***Comments on the validation of
Grid Connected Energy efficient power generation by Nabha Power
Limited, India
7 April 2011***

CDM Watch respectfully submits the following comment on the Project Design Document (PDD) for “Grid Connected Energy Efficient Power Generation by Nabha Power Limited”, India.

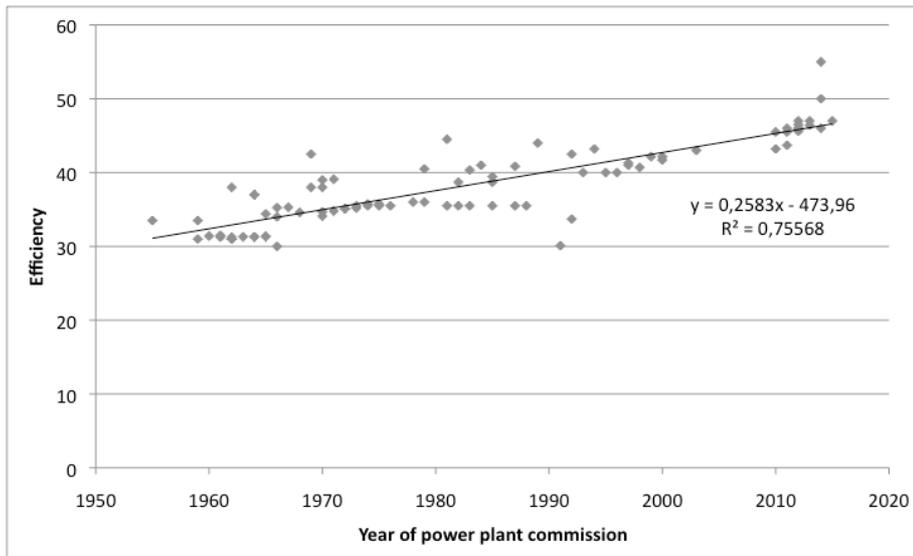
- The figure below from IEA (2008b, page 51) illustrates the efficiency improvements achieved in coal fired power plants in China. The figure shows that power plants between 100 and 400 MW, constructed in the last 10 years are 5-6% more efficient than power plants constructed in the ten years previously. This results in efficiency gains of 0.5% to 0.6% per year for power plants built in the most recent decade. The figure also shows that the improvements vary with the size of power plants and over time.

Against the above said, project developers must show how the project takes into account the baseline efficiency improvement.
